SUNDRY NOTICES AND REPORTS ON WELLS

Jicarilla 95 10

PLUG AND ABANDONMENT PROCEDURE

Proposed P&A

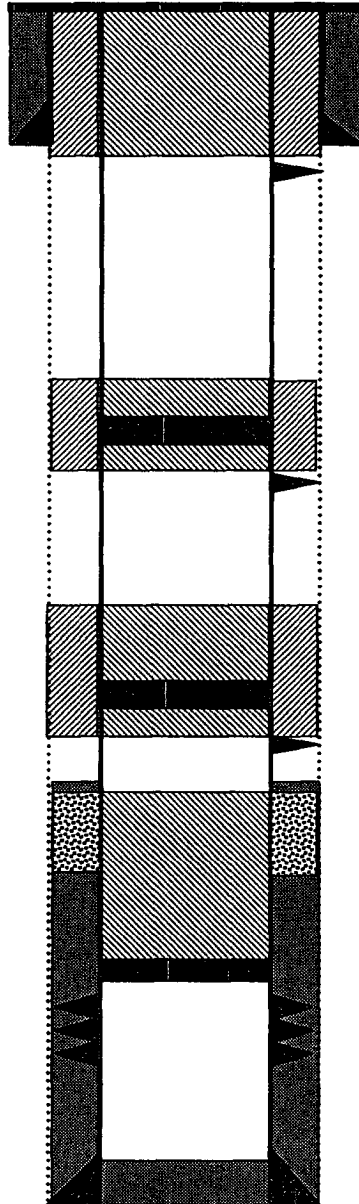
6. **Plug #3 (Nacimiento top, ^{2290 2190}~~2436~~ – ²²⁹⁰~~2036~~)**: Perforate 2 bi-wire holes at ²²⁹⁰~~2436~~'. Attempt to establish rate into squeeze holes if the casing pressure tested prior to perforating. Set 3.5" cement retainer at 2088'. TIH and sting into CR. Establish rate into squeeze holes. Mix and pump 31 sxs cement, squeeze 25 sxs outside the casing and leave 6 sxs inside casing to cover the Nacimiento top. TOH and LD tubing.

Plug #3: 2138' - 2038'
Type III cement, 31 sxs:
25 sxs and 6 sxs

Perforate @ 2138'
